## BCA ASSESSMENT REPORT

**Oakdale Central Lot 3, Buildings 3A, 3C and 3D  
Milner Ave Horsley Park**

**Client: Goodman Property Services**

Revision 4

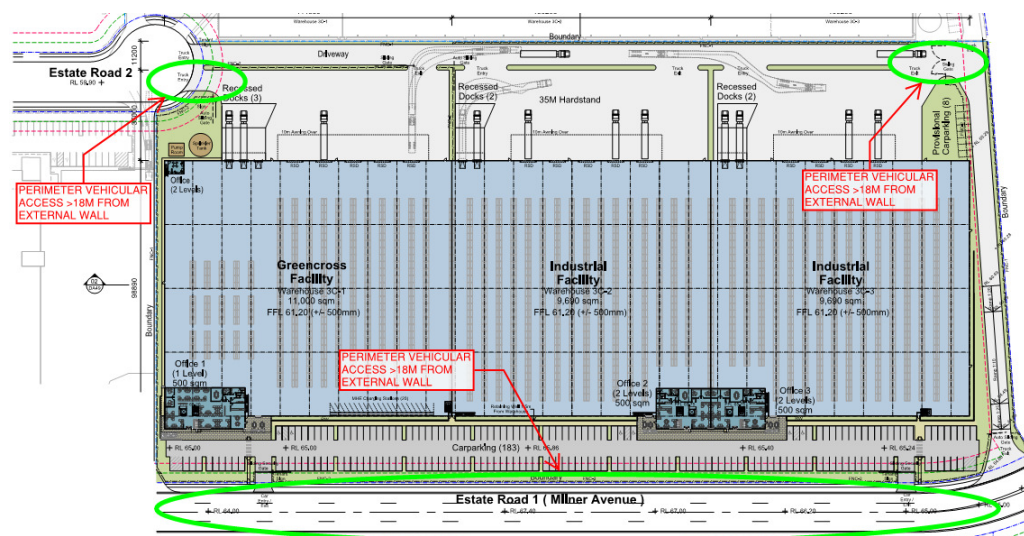
- + 3A -1 and 3A-2 – Vehicular Access is greater than 18m from the building; and the vehicular access is discontinuous in the NE corner of the building – see mark-up below.

alternative solution by the Fire Safety Engineer to demonstrate compliance with Performance Requirement CP9 - refer to the dot points and the diagram below for details of the proposed non-compliance issues:

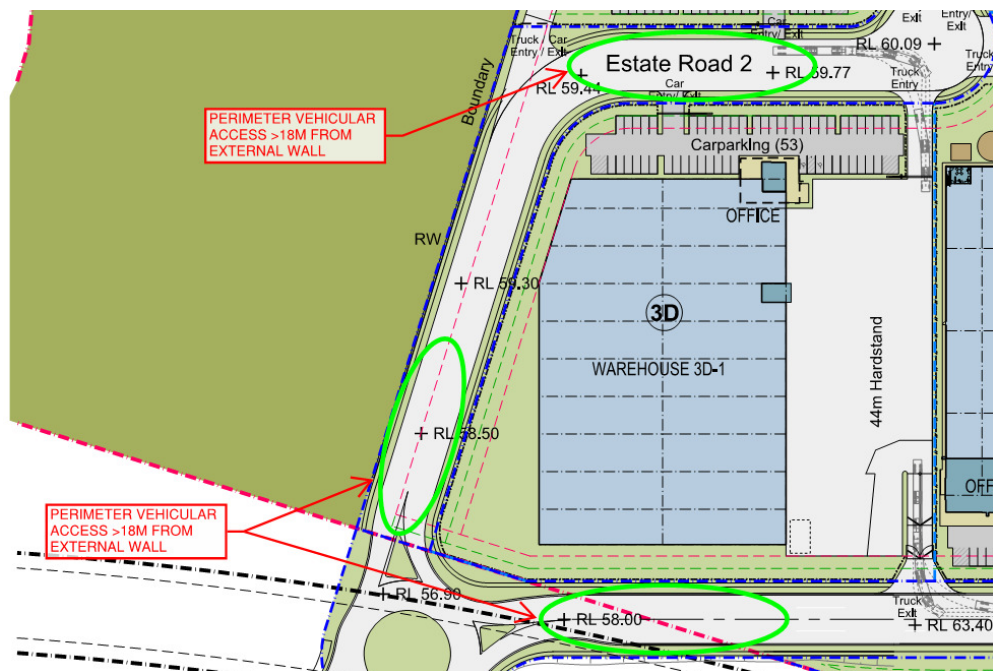
- + Lot 3C – Vehicular Access is provided on the southern side of the building via the Milner Ave which is greater than 18m from the building and the NW & NE corners of the building the vehicular accessway is also greater than 18m from the external wall of the building – see mark-up below.
